Technical Service Bulletin

Subject: GREEN RESIDUE ON OUTER SURFACE OF COOLANT RESERVE TANK	Bulletin No.: 01-005/26
	Last Issued : 02/25/2026

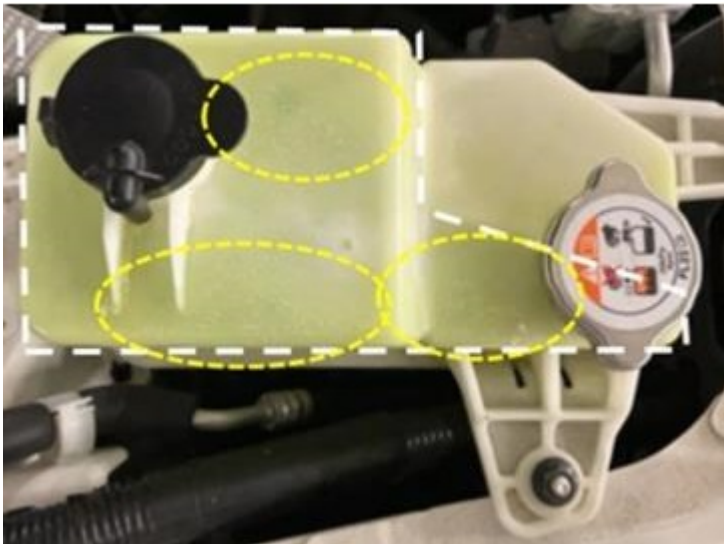
Some vehicles may exhibit green residue (yellow circle) on the outer surface of the coolant reserve tank, which appears to be coolant blowback.

This is caused by coolant seeping out and appearing as leakage from small pores (slight gaps) formed due to the deterioration of the coolant reserve tank (sub) material. To eliminate this concern, the material of the coolant reserve tank (sub) will be modified.

1. Verify the customer concern.
2. Replace the coolant reserve tank with a modified one according to the instructions in MGSS.
